PD 835

Re: **Administrative Relief request for Waterway Residential Business
Planned Development No. 835, Trump International Hotel and
Tower, 401 North Wabash Avenue**

Re: 52064600 – Trump International Hotel and Tower: 401 N. Wabash Ave., Chicago, IL
REQUEST FOR ADMINISTRATIVE RELIEF

TENANT BUILD-OUT TRUMP SPA & HEALTH CLUB LEVELS 14 & 14M

DATE: 08/14/14
 BY: [Signature]
 I-314

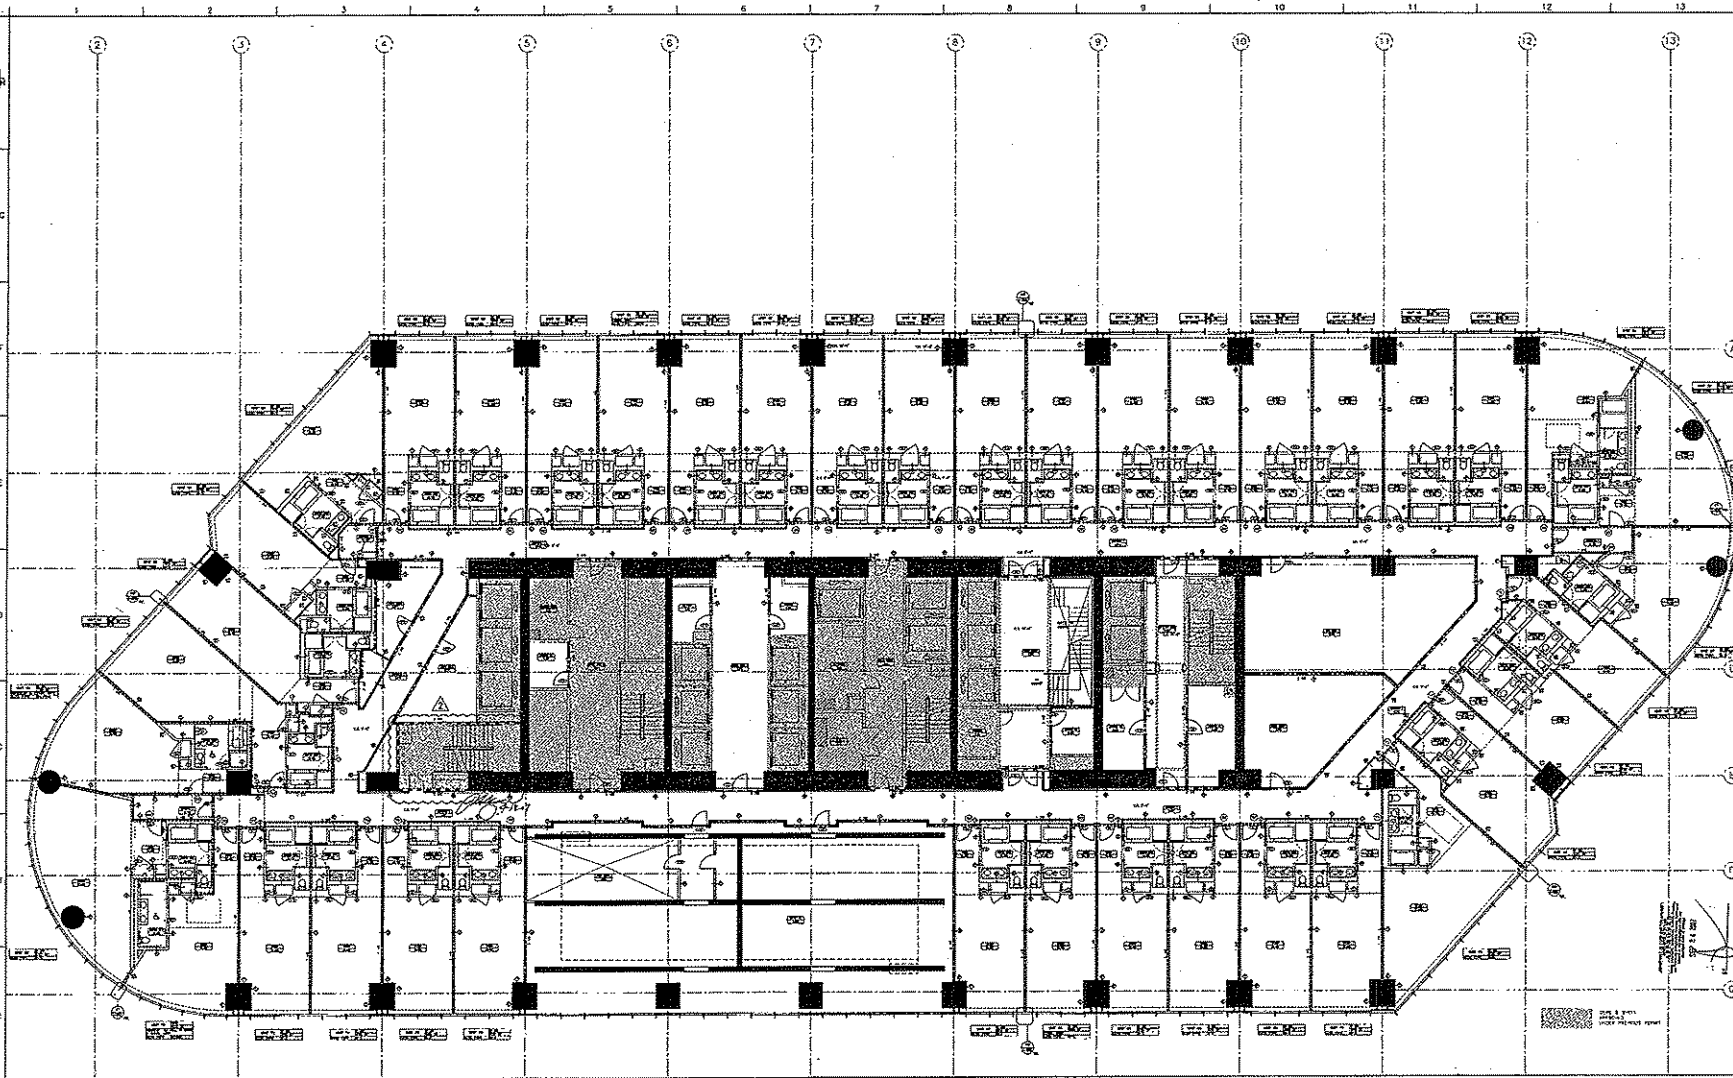
Specifically, you are requesting to clarify that the interior build-out of floors 14 and 14M of the above-referenced building will include 53 daily rental spa suites as shown on Sheets I-314 and I-314M, Spa Hotel Level 14 and Level 14M Overnight Spa Rooms Key Plans, prepared by Skidmore, Owings & Merrill LLP, and dated February 5, 2007. The Trump International Hotel and Tower has a current unit count of 486 residential units and 286 hotel units. The addition of these 53 spa suites will increase the hotel units to 339. There is no maximum number of hotel units identified in the PD.

We are requesting administrative relief, a minor adjustment to the planned development to the above referenced project. Specifically, we wish to clarify that the interior build-out of floors 14 and 14M includes 53 daily rental Spa Suites. Attached please find the permitted plans which detail the layout of these floors, including the Spa Suites.

With regard to your request, the Department Zoning and Land Use Planning has determined that the addition of 53 additional hotel units will not create an adverse impact on the Planned Development or surrounding neighborhood, will not change the character of the development, and therefore, would constitute a minor change.

Accordingly, pursuant to the authority granted by the Chicago Zoning Ordinance and Waterway Residential Business Planned Development No. 835, I hereby approve these changes but no other changes to this Planned Development.
